Technical Drainage Study Addendum #1

Summerlin Village 25 Parcel G

5523-A078

April 26, 2022

DRAWING
G1
4 OF 53 SHTS

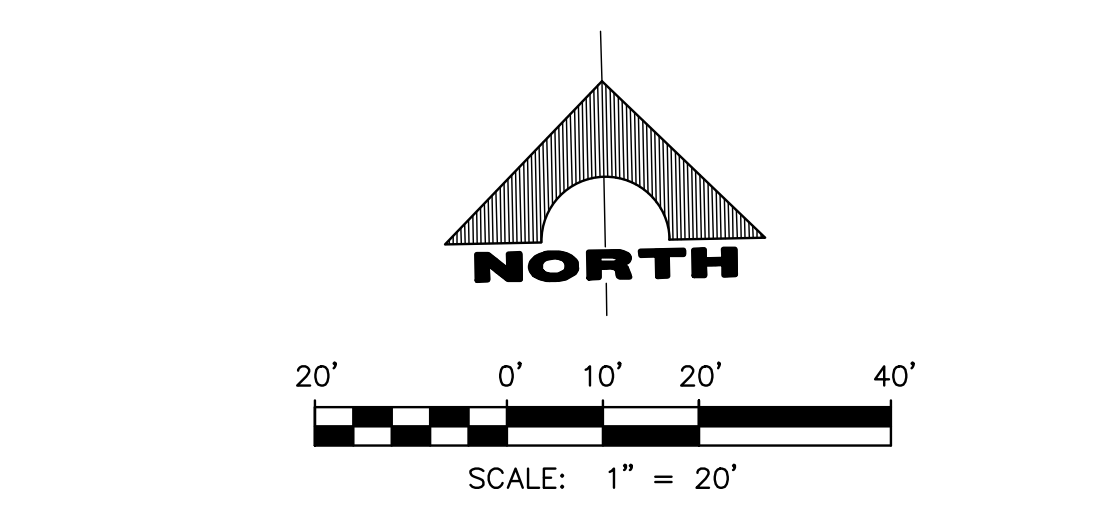
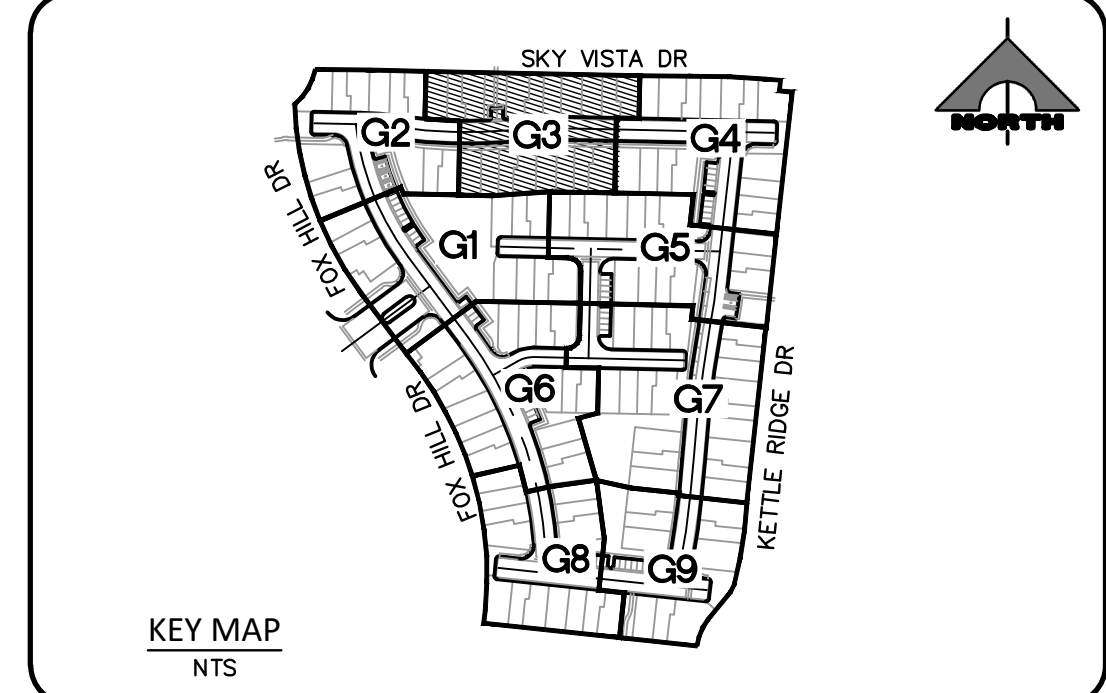
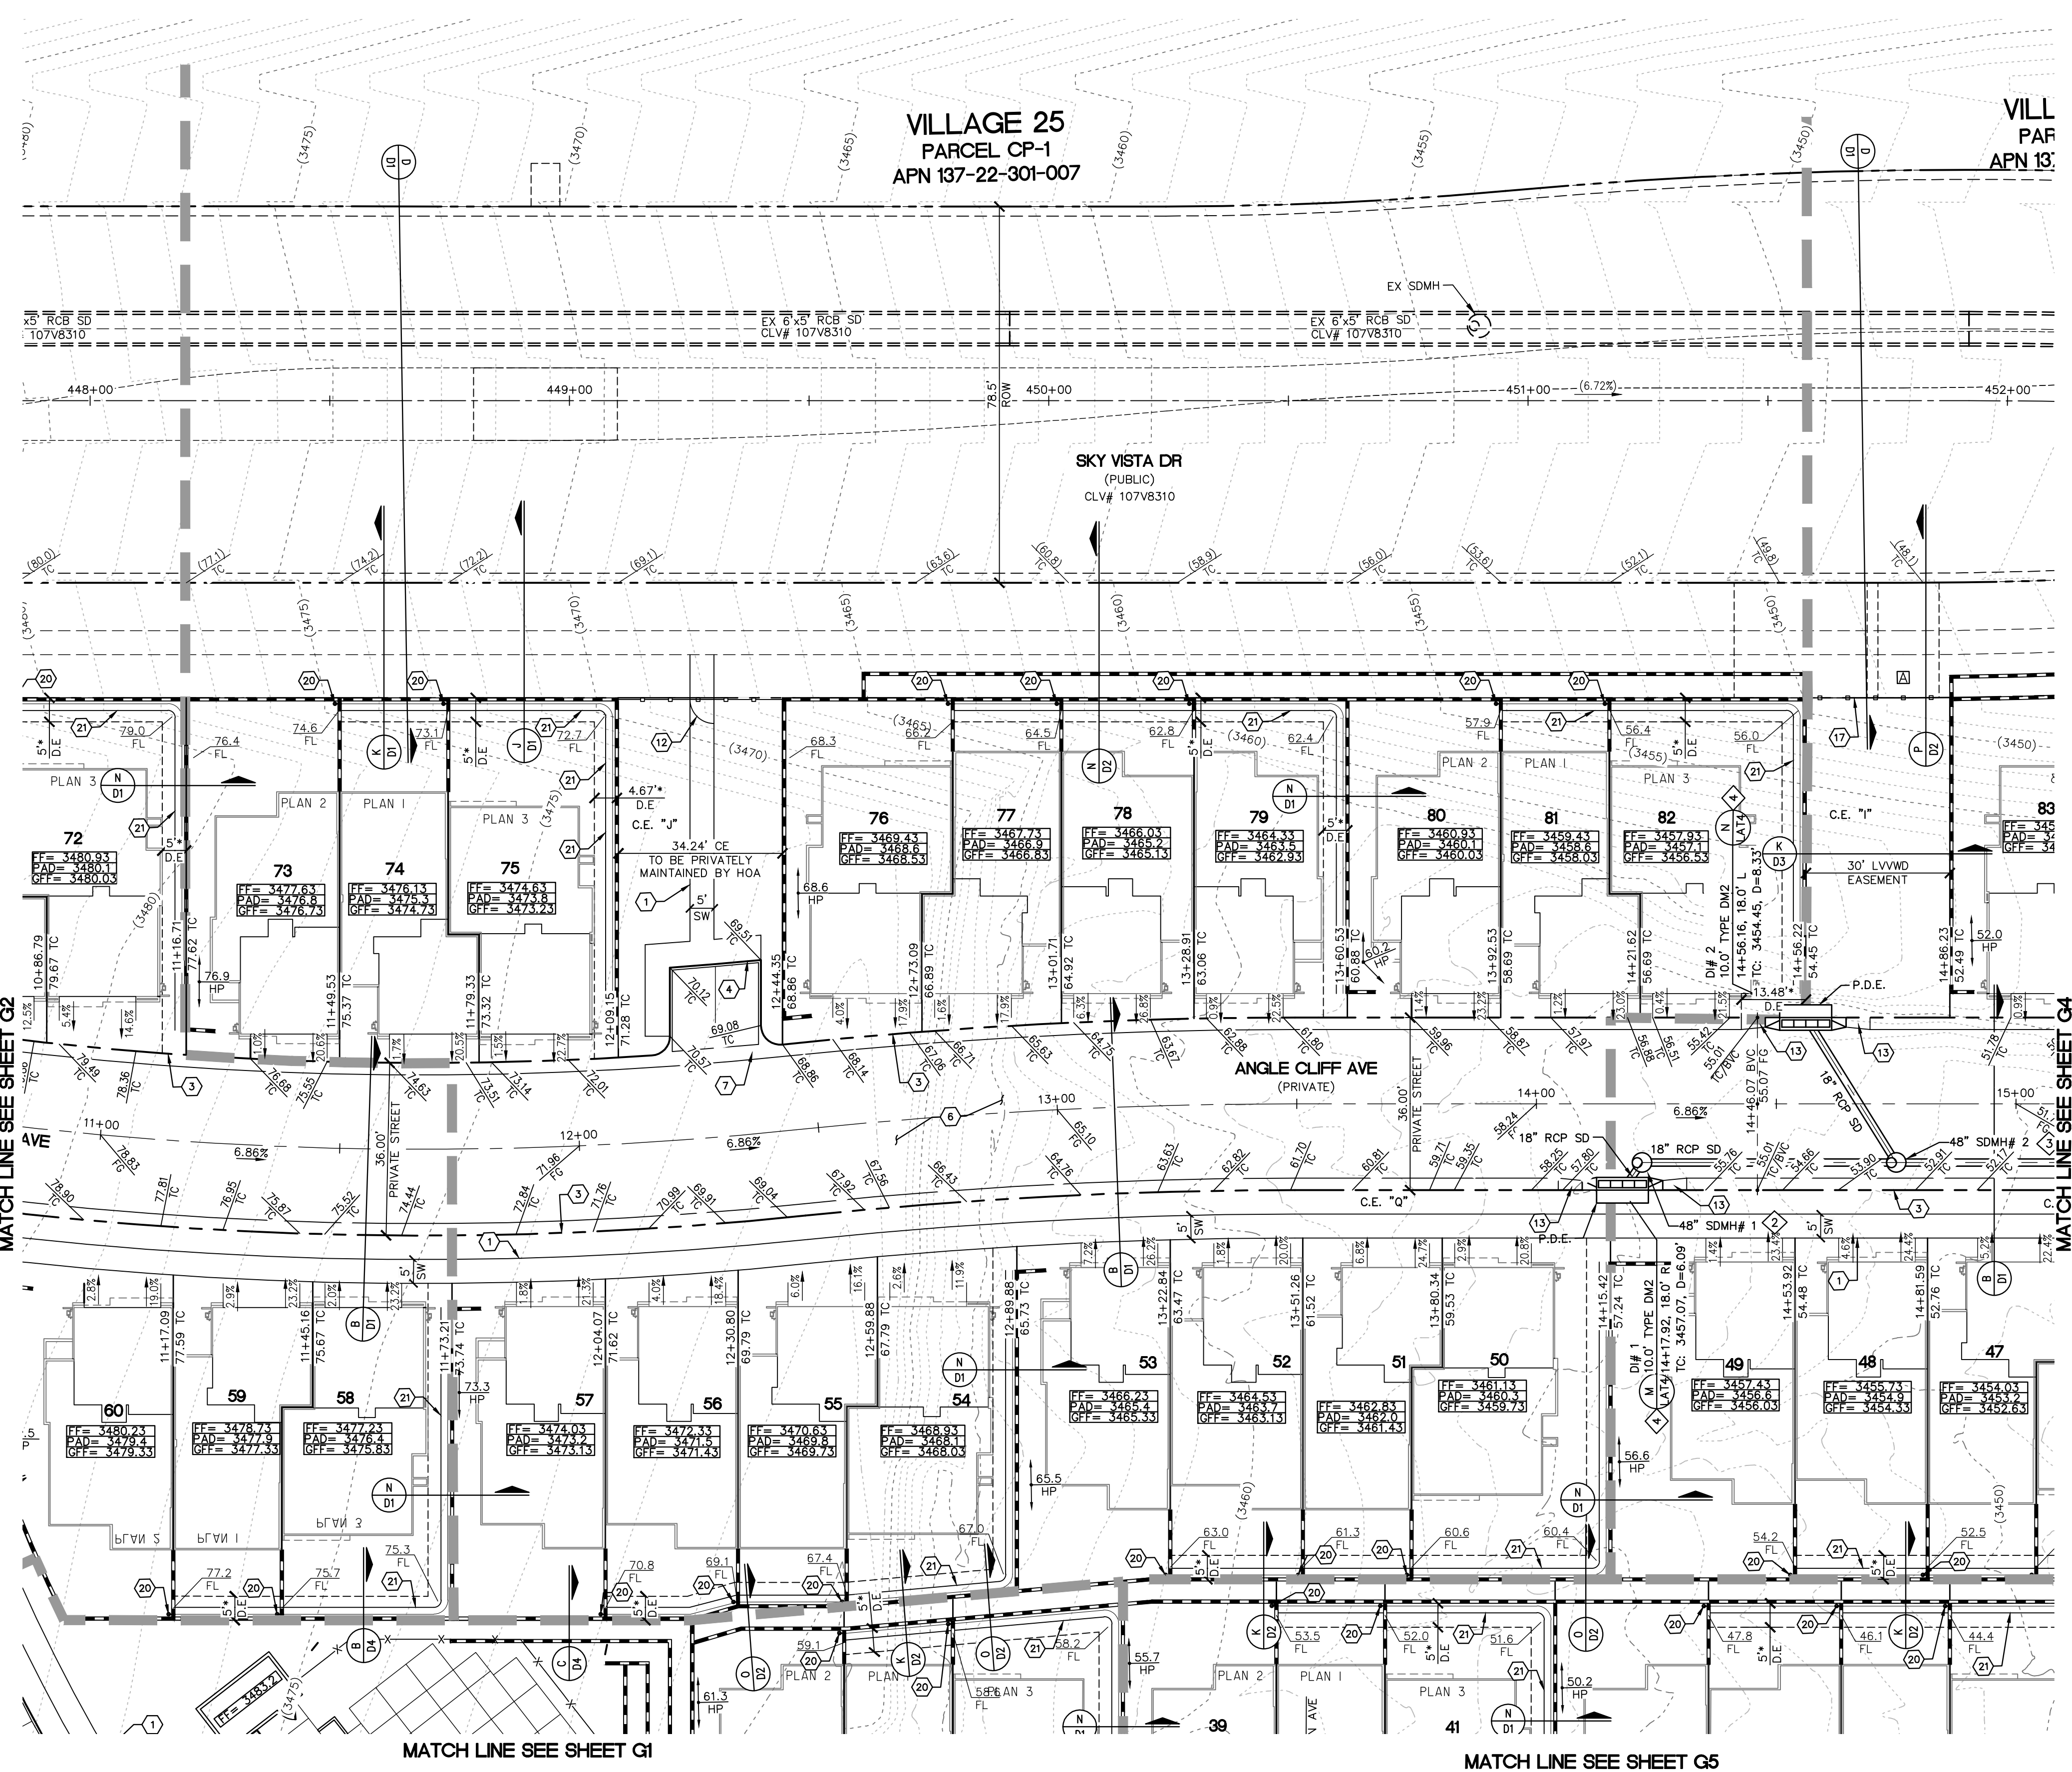
- Cross section details still do not reflect the associated L-curb or valley gutter within the proposed 5'-PDE. For example: **Sheet G1**: At the backyard of Lots 32-35, *Detail K/D2* did not show the L-curb. Same for *Details K/D1, J/D1 and H/D2* etc. Perform an overall check for all pertinent detail sections in the next submittal.

2. Cross section details still do not reflect the associated L-curb or valley gutter within the proposed 5'- PDE. For example: Sheet G1: At the backyard of Lots 32-35, Detail K/D2 did not show the L-curb. Same for Details K/D1, J/D1 and H/D2 etc. Perform an overall check for all pertinent detail sections in the next submittal.

Corrected, see detail sheets.

YARD DRAIN

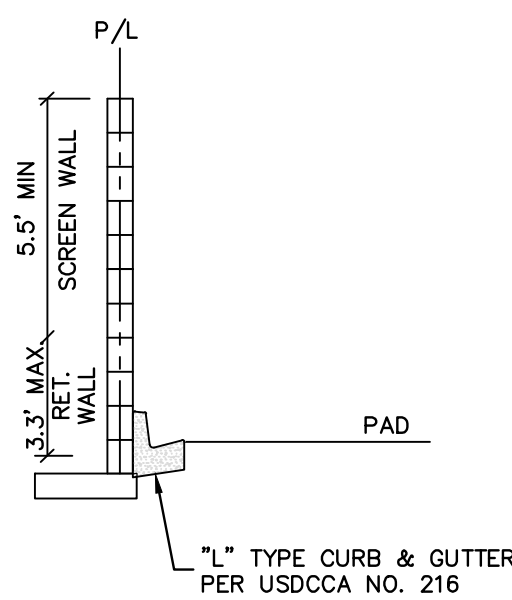
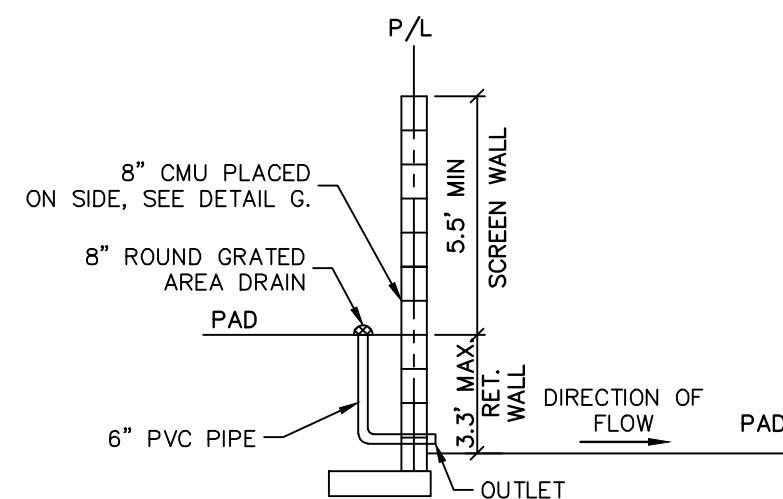
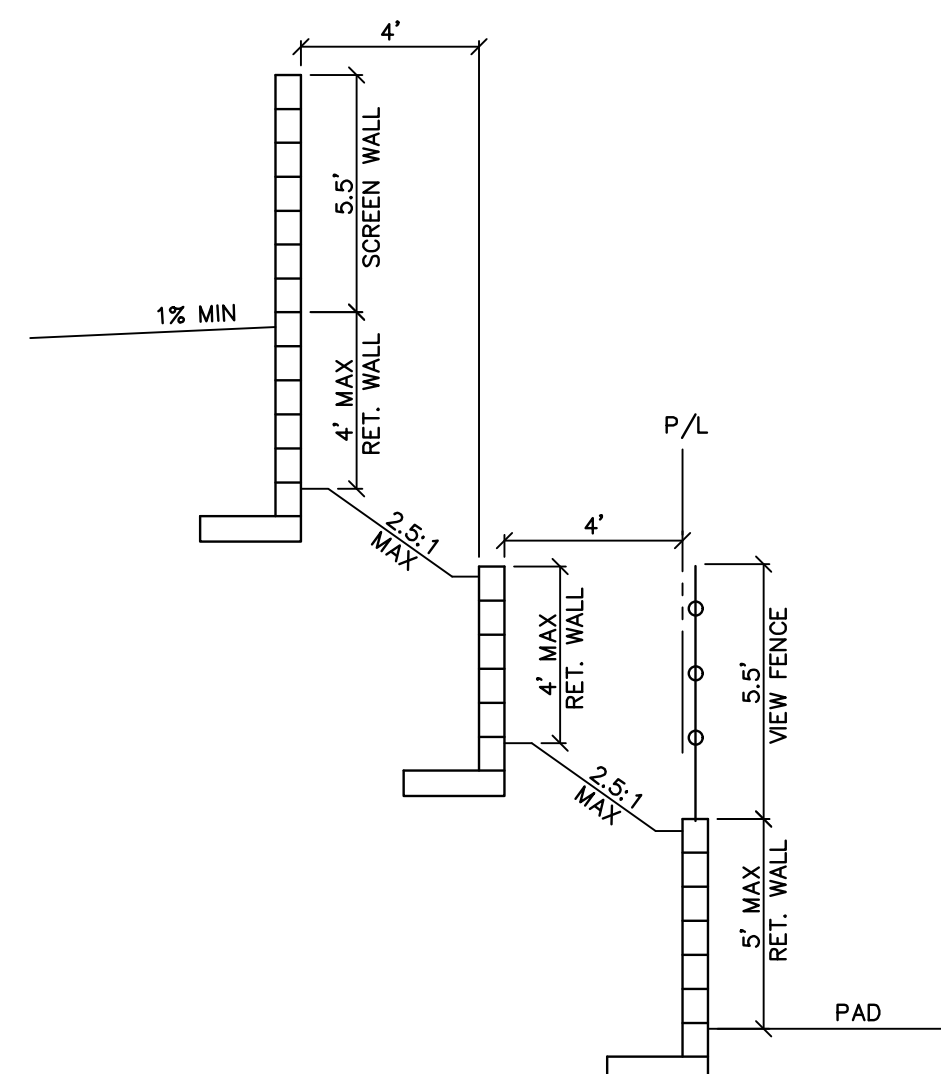
1. The last submittal revised the typical drainage pattern in the backyard area. Previously, the backyard within the 5'-PDE drains through lot lines on surface. The last submittal replaced with a yard drain inlet and a 4"-pipe through the wall, surface flow until it reaches another yard drain inlet and repeat. However, this creates couple problems:

- There is no indication of any wall openings at lot lines. If the yard drain is totally clogged, there will be no overflow path and the back yard or even the adjacent house will be inundated. Address and resolve in the next submittal.
- 4"-pipe is small and can be clogged frequently. Pipe also can be broken and will cost the pertinent homeowner time and money down the road. For small area lot to lot drainage, it is recommended to have surface flow as possible because that will require the least maintenance cost and frequency. Review and revise accordingly.

Pipes increased to 6" as well as sideways block wall opening provided in case pipes become clogged per request. See detail sheets.
